Appendix E:
Correspondence with MTCS

**Reference: Amherst Island Wind Energy
Project Layout Modifications**

Reference: Amherst Island Wind Energy Project Heritage Assessment – Project Layout Modifications

Reference: Amherst Island Wind Energy Project Protected Properties – Project Layout Modifications

Project Location & Study Area: Proposed Modifications

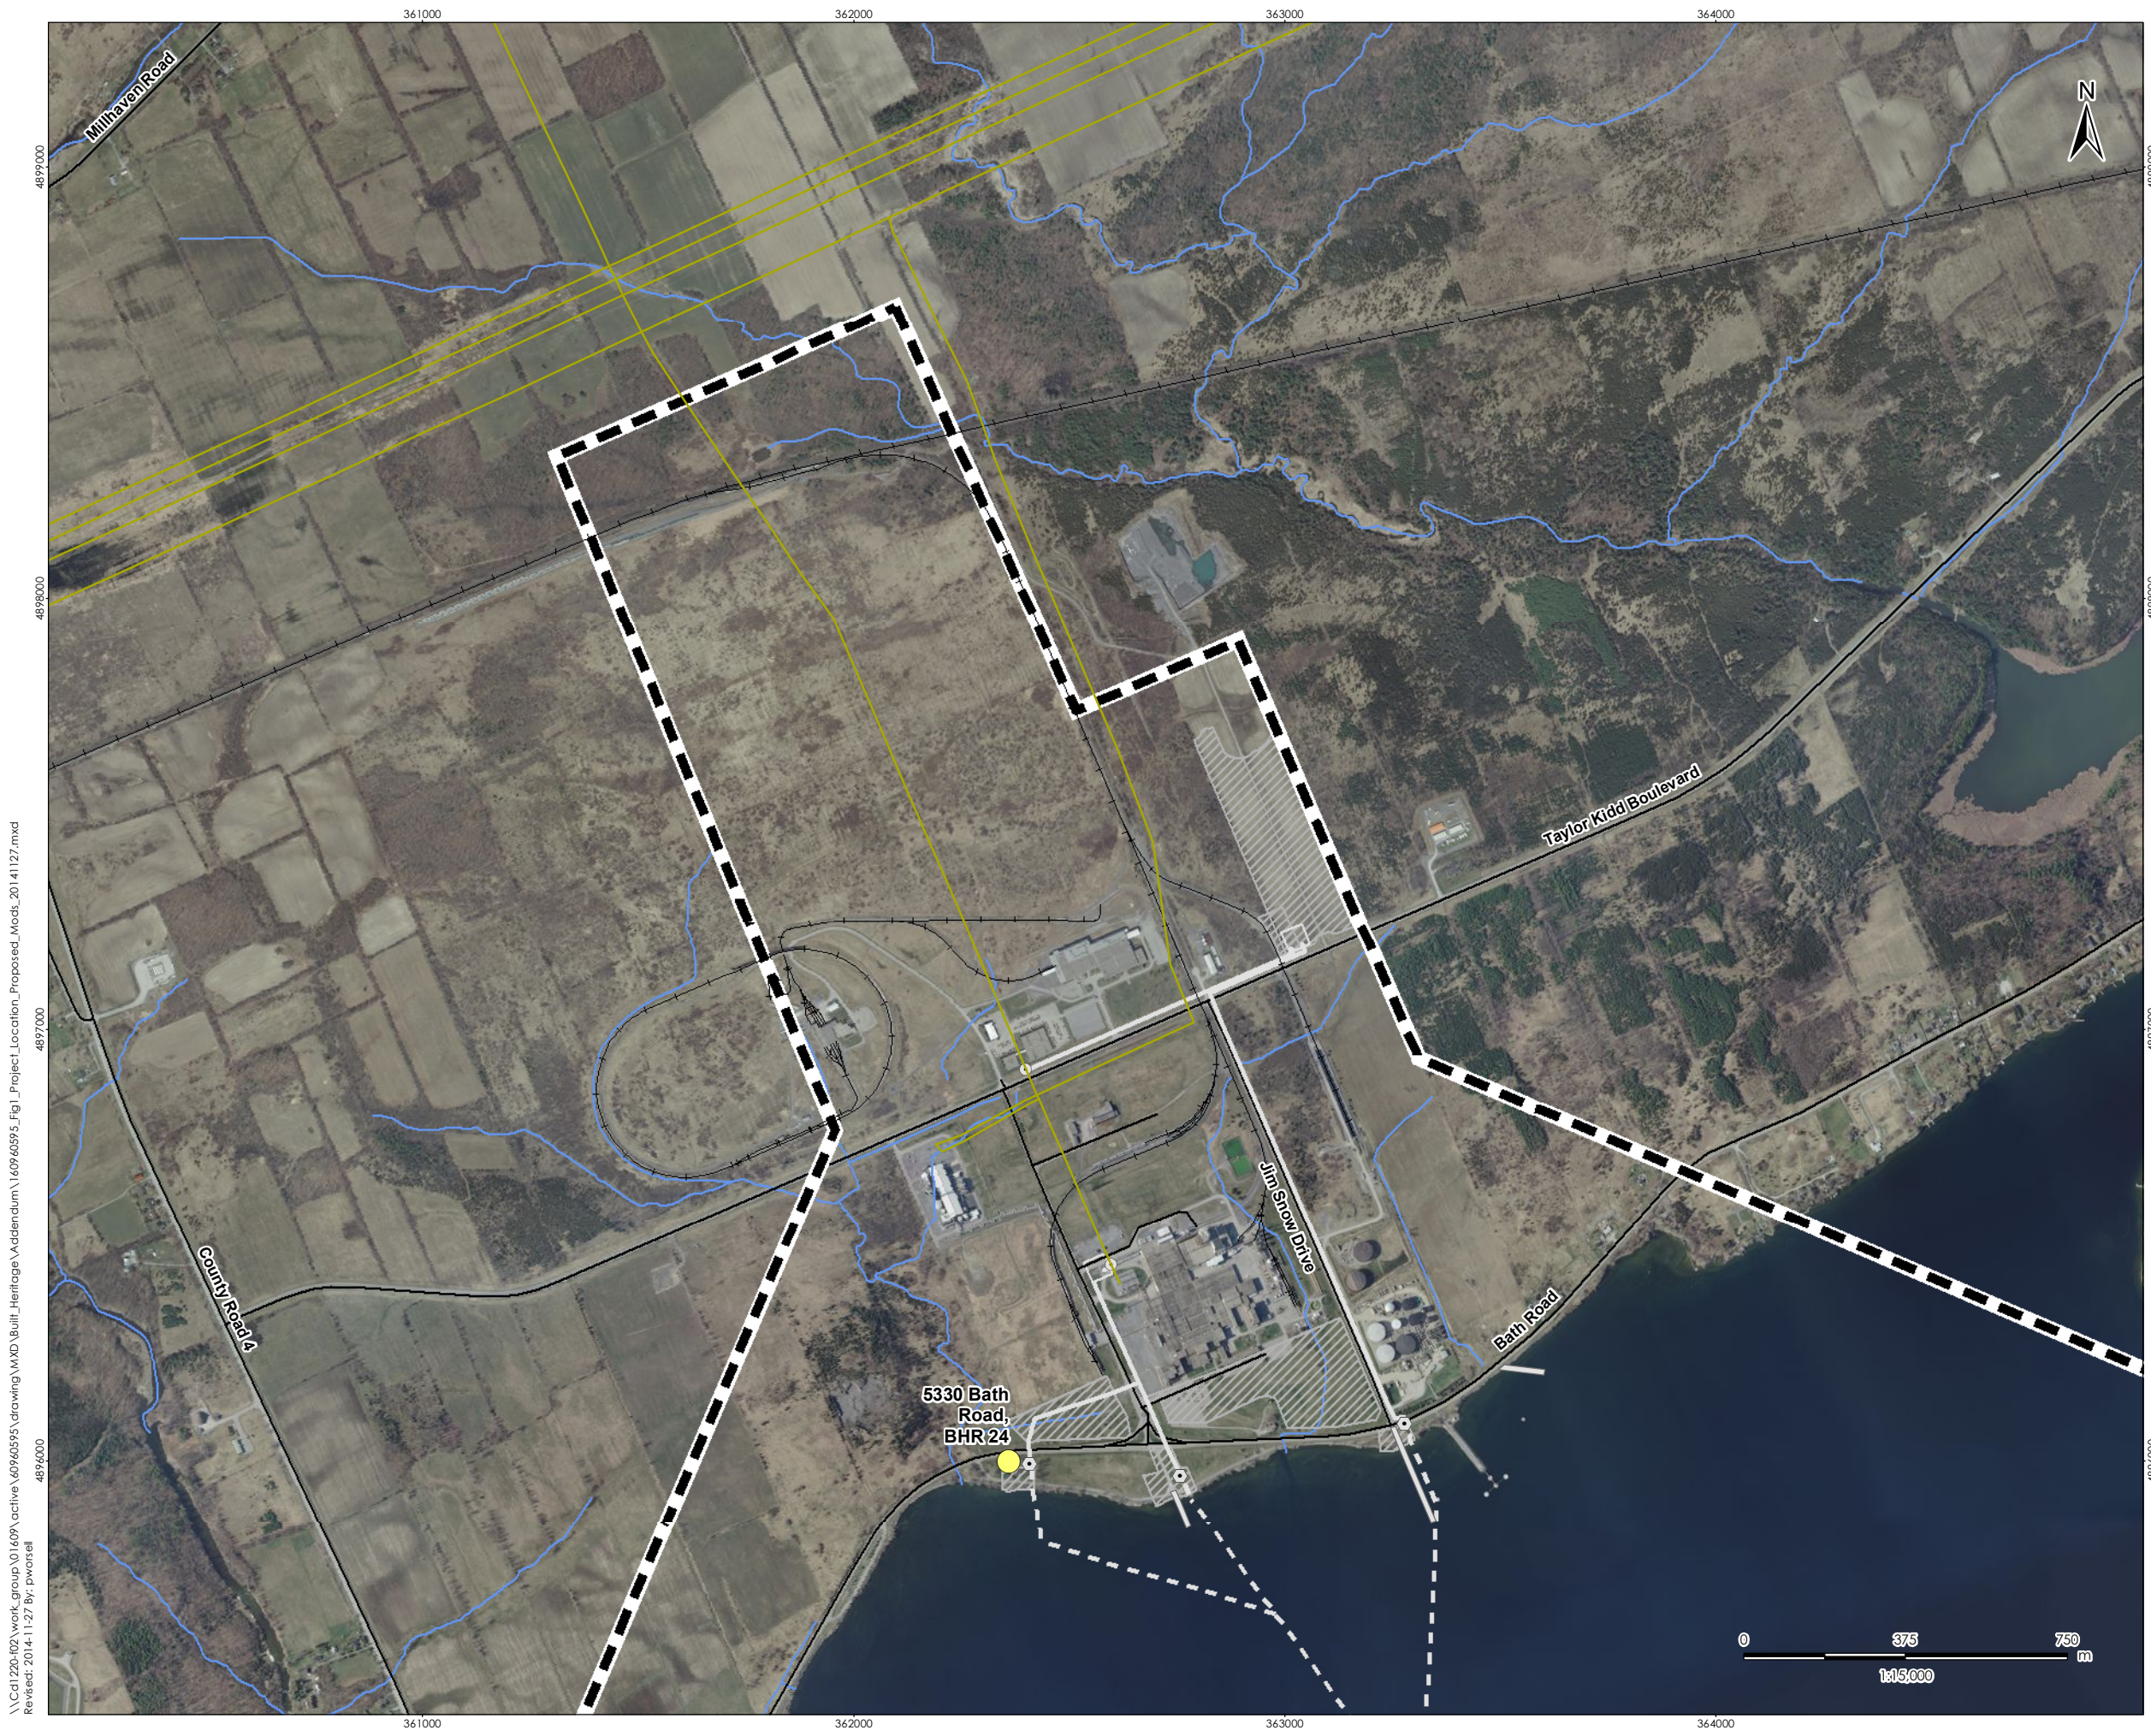
- a) The reduction in the number of Wind Turbines by changing the Turbine Model (Siemens 2.942 MW and 2.772 MW) (see **Figure 1A, Attachment 1**);
- b) The addition of an underground collector line along a previously approved access road between T16/T23 and T35 (see **Figure 1A, Attachment 1**); and
- c) The addition of an underground collector line along South Shore Road and up to S13 (see **Figure 1, Attachment 1**). Along with the removal of the portions of the proposed underground collector line along Stella 40 Foot Road and Front Road.

- a) Reducing the number of Wind Turbines by changing Turbine Model (Siemens 2.942 MW and 2.772 MW)

This technical change involves changing the Project's turbines from a combination of Siemens 2.3 MW and 2.221 MW to a combination of Siemens 2.942 MW and 2.772 MW, and thereby reducing the number of turbines from 36 to 27. The new turbines would be physically identical, specifically with a hub height of 99.5 m and rotor diameter of 113 m. The modification will decrease the Project Location size by reducing the number of turbine sites from 36 to 27. All of these 27 turbine sites are in previously studied and proposed locations.

b) Collection System Route Change – Reducing Impacts on 2nd Concession

Another technical change would involve the addition of an underground collector line along a previously approved access road between T16/T23 and T35. This underground collector line has been incorporated into the design of the access road between T16/23 and T35. Because the collector line will use the same corridor as the previously studied and proposed access road, the Project Location will not be changed, and therefore there will be no new features to be considered within 120 m of the Project Location. The addition of the underground collector line route provides Windlectric Inc. with greater design flexibility. The construction and installation activities for this underground collector line will be completed in the same manner as the collector lines which are described in the Construction Plan Report, submitted as part of the Renewable Energy Approval (REA) Application.

c) Collection System Route Change – Avoiding the Village of Stella

This proposed modification would involve rerouting the collection system to avoid the Village of Stella. In doing so, this modification would remove a significant portion of the existing collection system from S30 entrance along Front Road, including removing approximately 4 km of road allowance trenching (including through Stella). The modification would also require a new collection corridor from S13 to South Shore Rd. and west to S14 entrance, which would consist of approximately 1 km in road allowance and 700 m of in pasture field. The modification will decrease the Project Location size by resulting in a net reduction of approximately 2 km of collection system trenching.

Attachment: Project Location & Study Area: Proposed Modifications

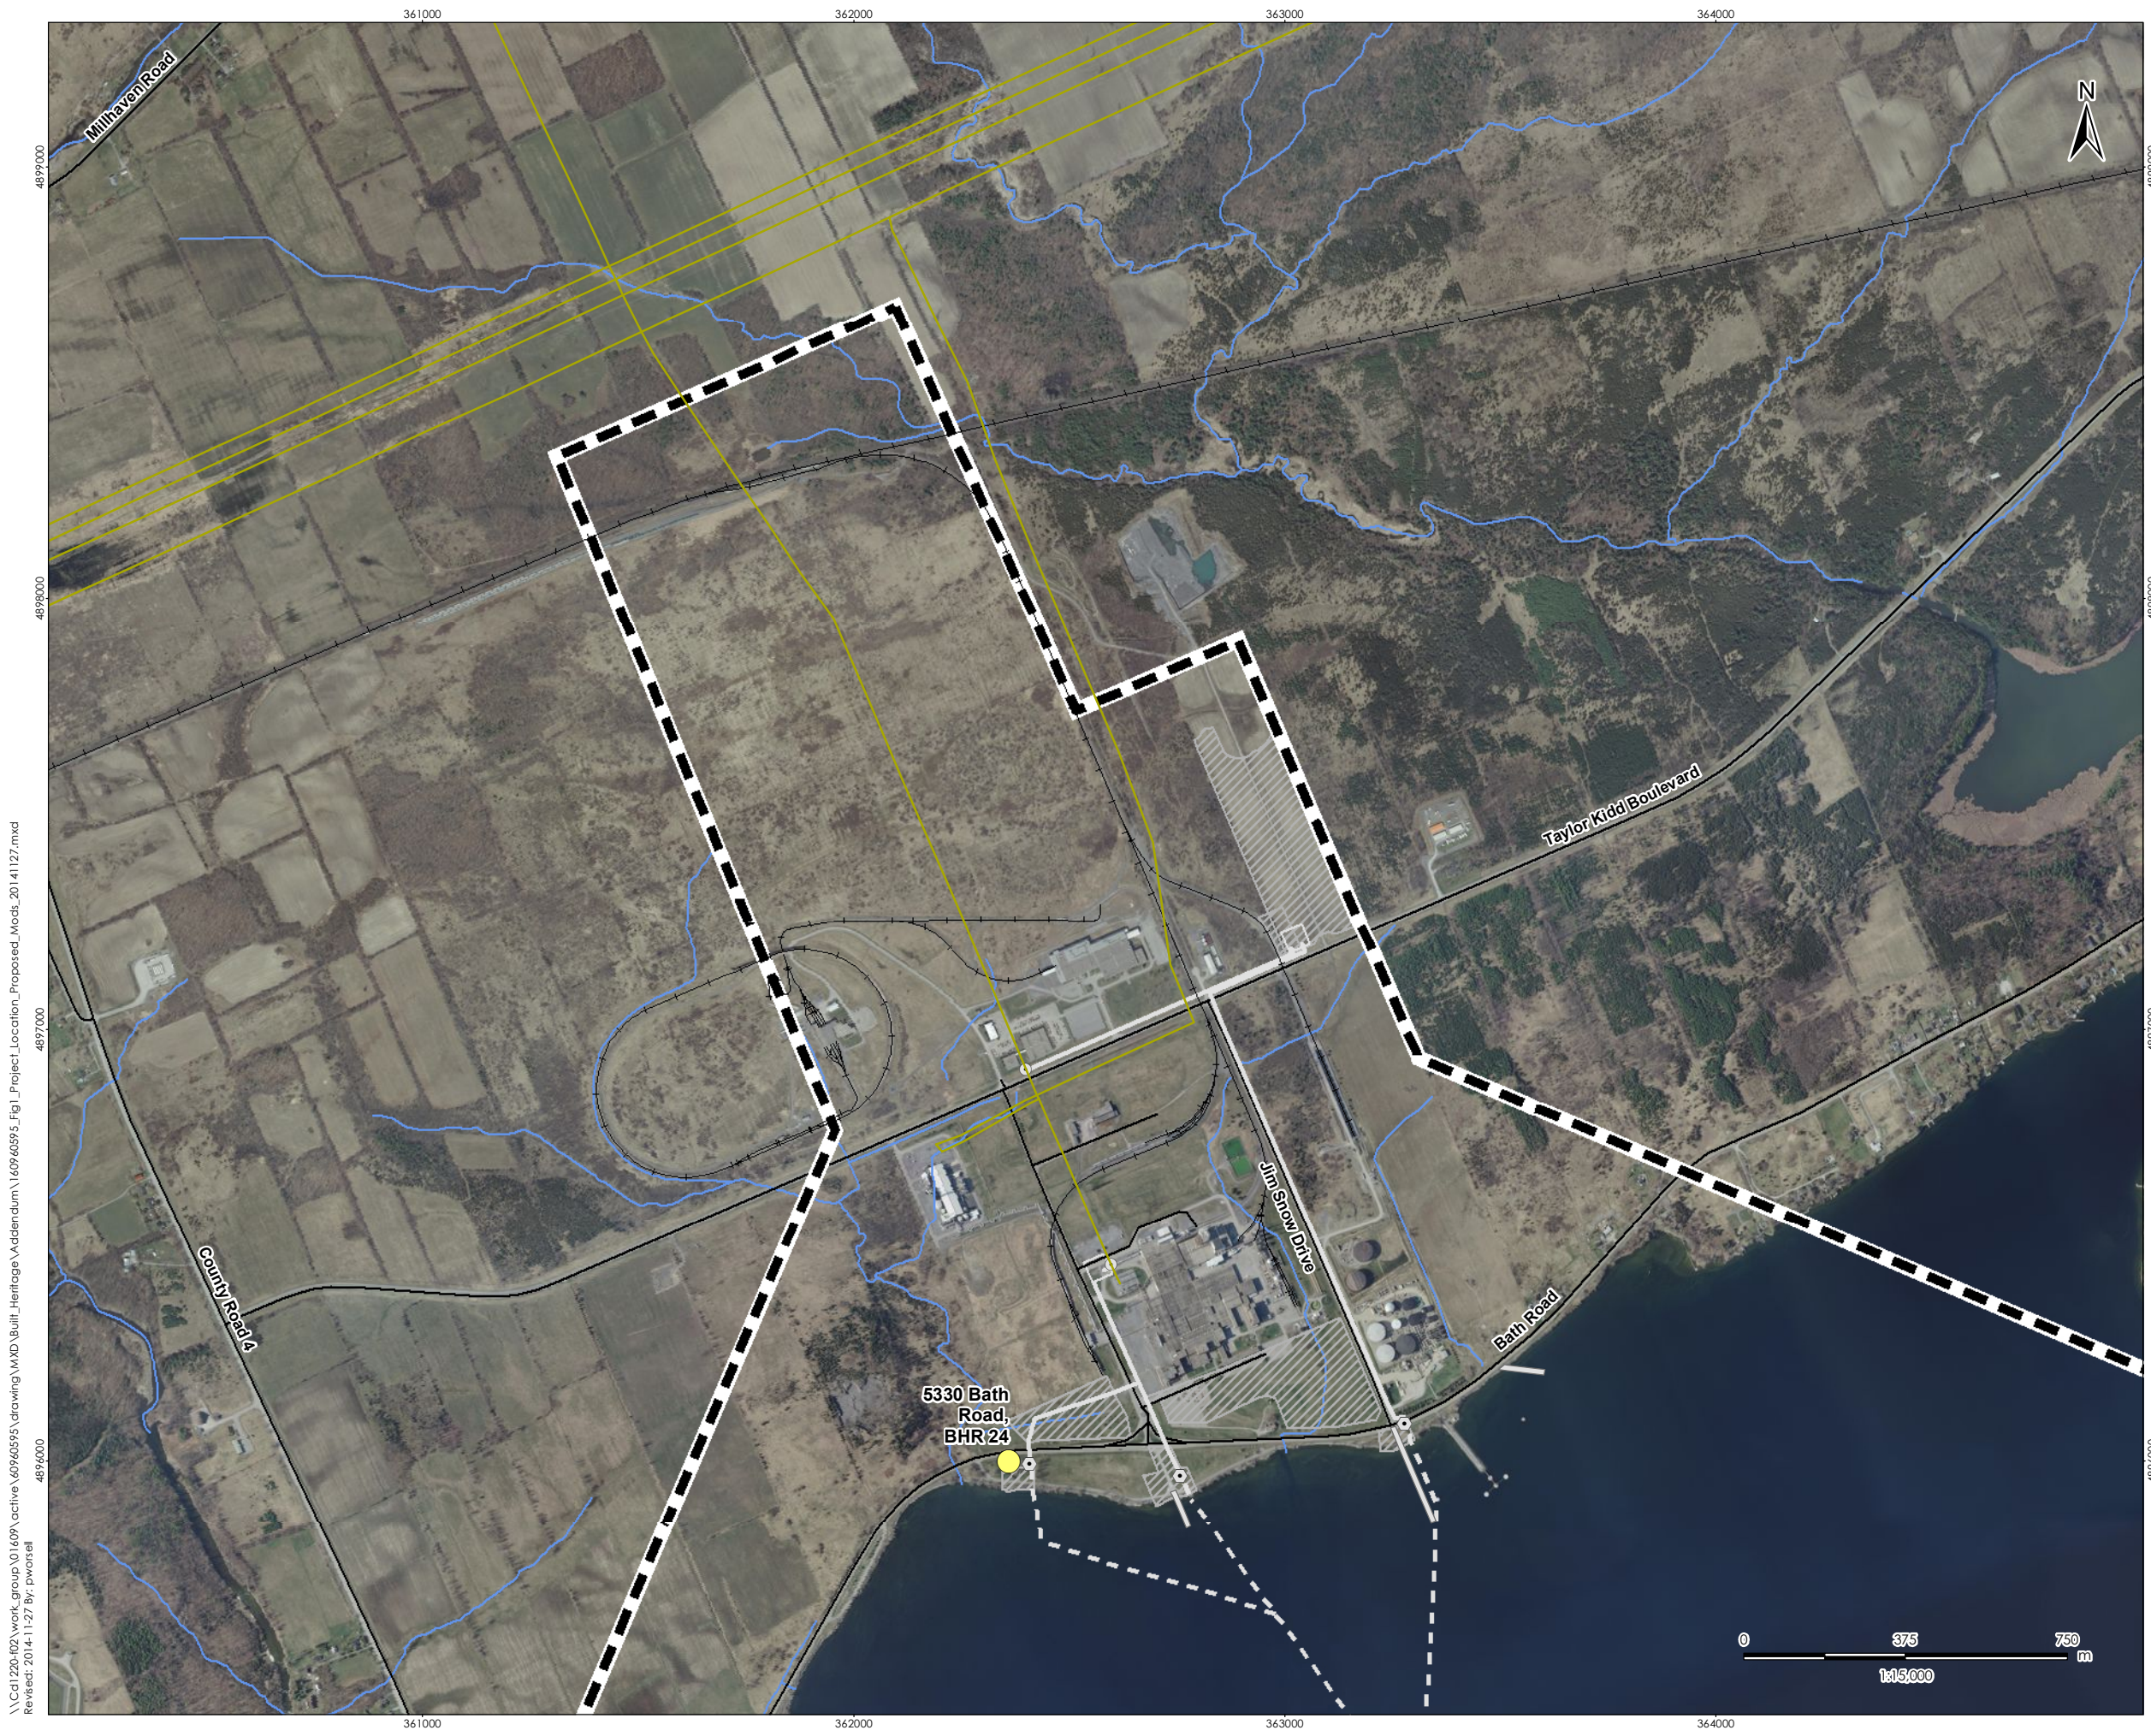
There are three modifications which have been proposed following the completion of the *Heritage Assessment* (see Figure 1). These are: (1) a change in turbine model and associated reduction in the number of turbines, (2) a change in collection system routing to avoid the Village of Stella and (3) changes to the road and collection system to avoid some activities on 2nd Concession.

This modification involves changing the Project's turbines from a combination of Siemens 2.3 MW and 2.221 MW to a combination of Siemens 2.942 MW and 2.772 MW, and thereby reducing the number of turbines from 36 to 27. The new turbines would be physically identical, specifically with a hub height of 99.5 m and rotor diameter of 113 m. The modification will decrease the Project Location size by reducing the number of turbine sites from 36 to 27. All of these 27 turbine sites are in previously studied and proposed locations.

2. Collection System Route Change 1 – Avoiding the Village of Stella

This proposed modification would involve rerouting the collection system to avoid the Village of Stella. In doing so, this modification would remove a significant portion of the existing collection system from S30 entrance along Front Road, including by removing approximately 4 km of road allowance trenching (including through Stella). The modification would also require a new collection corridor from S13 to South Shore Rd. and west to S14 entrance, which would consist of approximately 1 km in road allowance and 700 m of in pasture field. The modification will decrease the Project Location size by resulting in a net reduction of approximately 2 km of collection system trenching.

3. Collection System Route Change 2 – Reducing Impacts on 2nd Concession

This modification would involve the addition of an underground collector line along a previously approved access road between T16/T23 and T35. The collector line has been incorporated into the design of the access road between T16/23 and T35. The modification will decrease the Project Location size by eliminating the need to install a second collection circuit trench on approximately 3 km of 2nd Concession.
